GOVERNMENT OF THE DISTRICT OF COLUMBIA
DEPARTMENT OF TRANSPORTATION

MEMORANDUM

SUBJECT: BZA Case #18508, 2201 Georgia Ave, NW

Figure 1: Proposed Site Layout and Access.

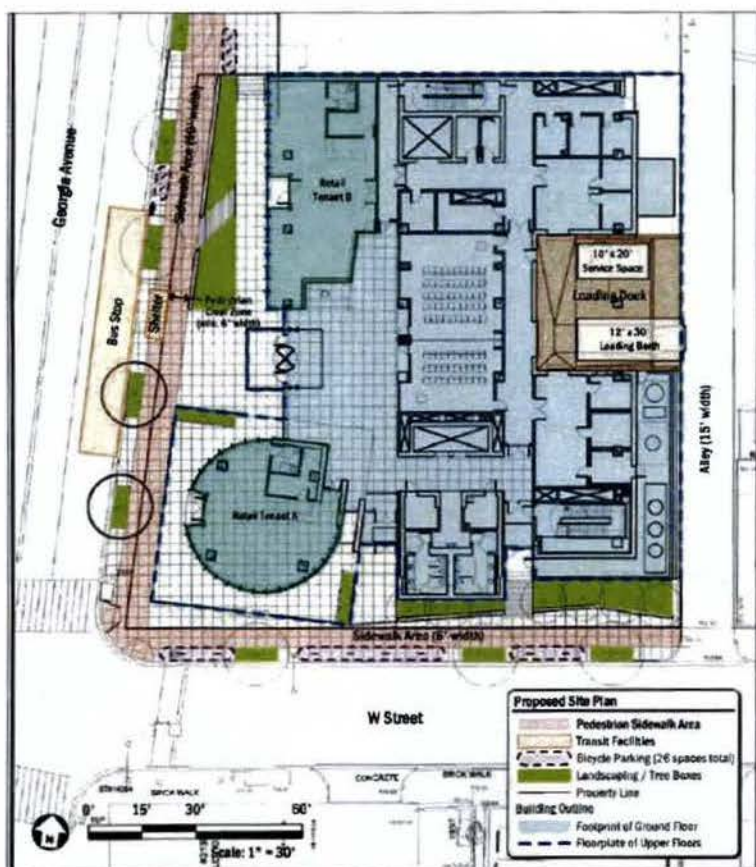
As shown in Figure 1, no vehicle access is proposed because the site will have no on-site parking. The site is served by a 15' north-south public alley that will be utilized for loading and deliveries. Bike access is provided by 26 proposed bike parking spaces in the public space and on private property fronting Georgia

Avenue and W Street Pedestrian access is from one building entrance on W Street and one entrance on Georgia Avenue Two separated retail establishments will have pedestrian access from the Georgia Avenue sidewalk

The Applicant is proposing to eliminate the three curb cuts that provide access to the existing parking lot and rebuild these entrances to DDOT sidewalk standards

According to the Applicant, the proposed academic building will contain lab and office space to accommodate existing research departments The Applicant estimated that the site will generate 90 AM peak hour non-vehicle trips to the site (80 in, 10 out) and 84 PM peak hour non-vehicle trips (15 in, 69 out) Of these trips, 95% are expected to be walking trips with the remaining 5% to be made by bike Accordingly, the project will generate additional pedestrian and bike traffic to a streetscape that does not currently have optimal pedestrian conditions. However, the Applicant is providing additional sidewalk width to increase the pedestrian clear zone space to accommodate both the existing pedestrian exposure and future demand generated by the site¹. DDOT acknowledges the Applicant's efforts in accommodating the existing and future pedestrian traffic, through the building setbacks However, the most recent site plan, shown in Figure 1, still shows a pinch point behind the Georgia Avenue bus shelter where the pedestrian clear zone width narrows from ten feet down to six feet DDOT has requested that the Applicant modify its proposed retaining wall design to increase the pedestrian clear zone at this pinch point

The Applicant is eliminating all existing curb cuts and is not proposing any new driveways. This will enhance pedestrian safety along Georgia and W Streets by reducing conflict points with vehicles in the public space. In addition, the Applicant is setting back structures from the property line to create a wider pedestrian clear zone on Georgia Avenue. Per DDOT Standards, the Applicant is providing 10' clear zone between the tree box and any on-site structures, as shown in Figure 1. However, as mentioned previously, a "pinch point" behind the Georgia Avenue bus shelter. The Applicant and DDOT held a Preliminary Design Review Meeting in January 2013 to discuss streetscape issues, including the pedestrian clear zone concerns. DDOT requests that the Applicant shift the proposed wall behind the Georgia Ave bus shelter to retain a 10 foot minimum clear zone space throughout.
